SUBJECT: INTAKE STRUCTURE REPAIR, SAN ONOFRE NUCLEAR GENERATING STATION,  
UNIT NO. 1 (TAC NO. 74168)

RAI ON REPAIR OF DEGRADATION  
OF INTAKE STRUCTURE AT SONGS-1

DCP # 1-3440.08C REV. 0 SHEET 17

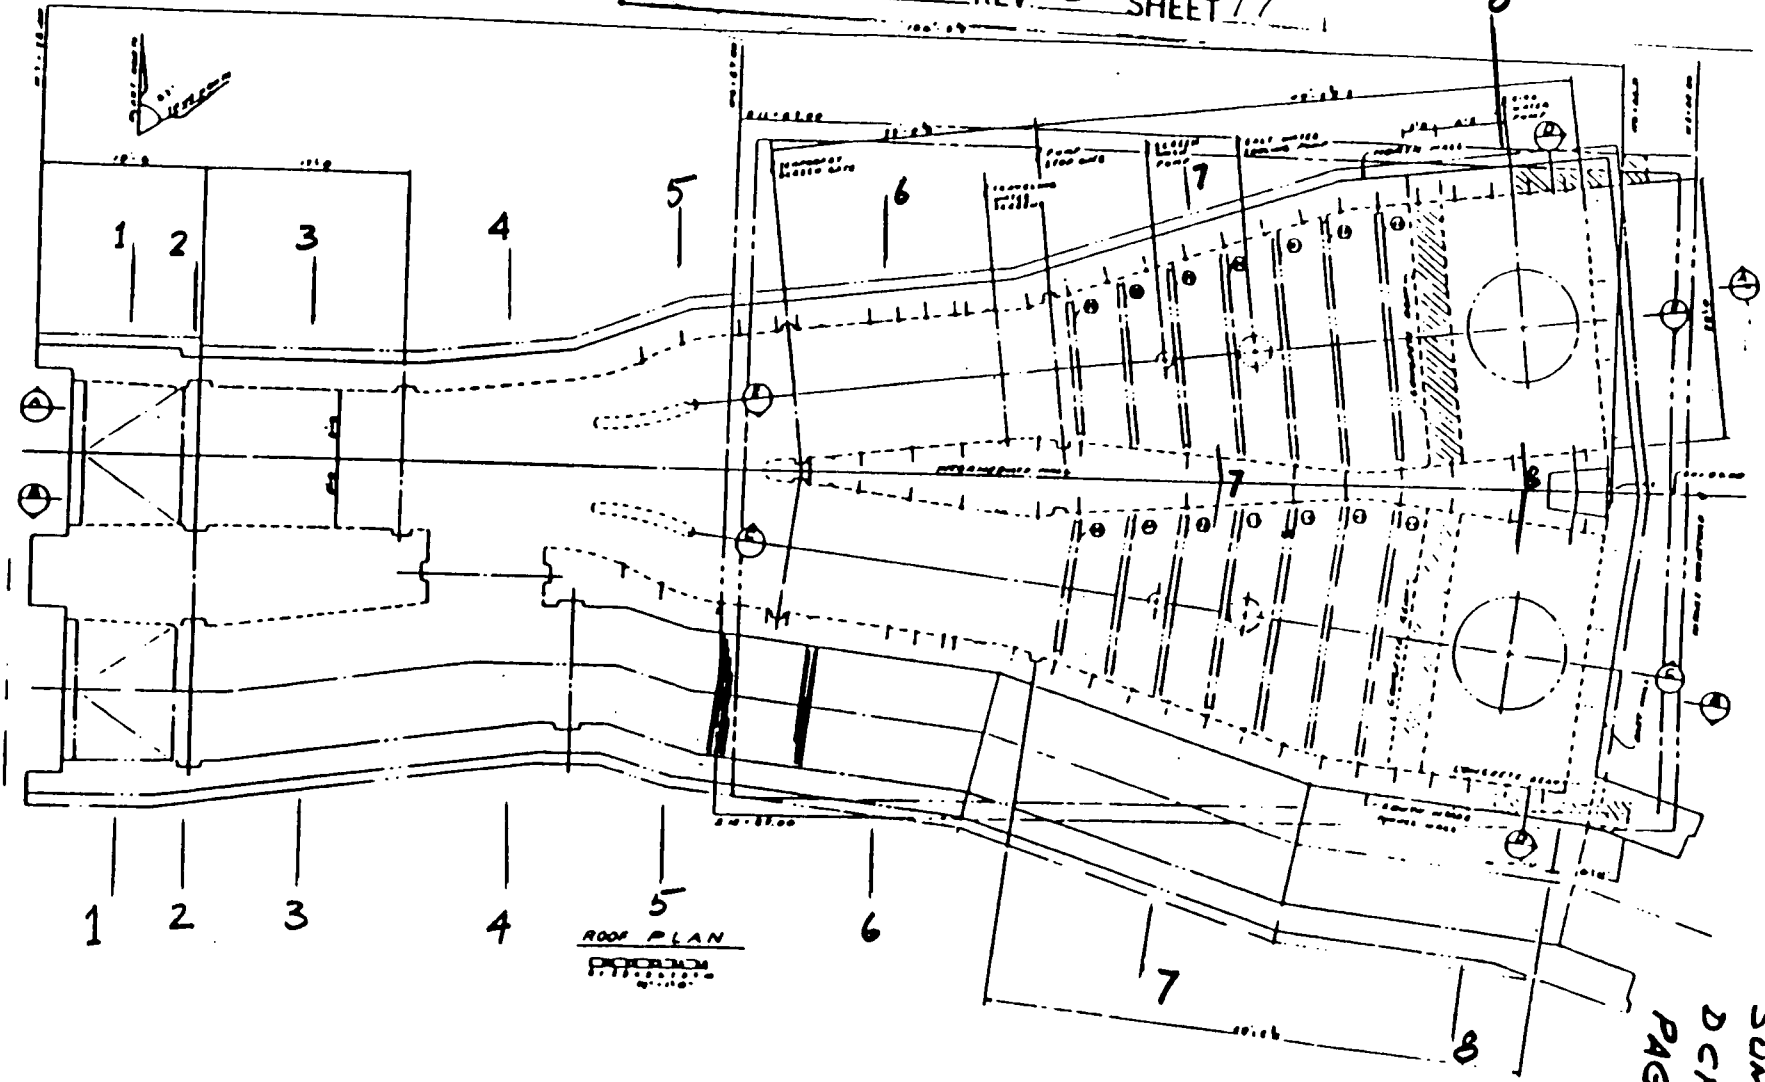
5. Provide cross-sectional details of sections (1-1 to 8-8) shown on the attached sketch (Attachment 1) indicating grade levels, water levels (normal and fluctuations), wall and slab thicknesses, beam dimensions, reinforcing provided, major embedments in concrete, and pump support locations. Also, indicate ground water fluctuations in the backfill, and foundation strata below the base slabs and around the tunnel.
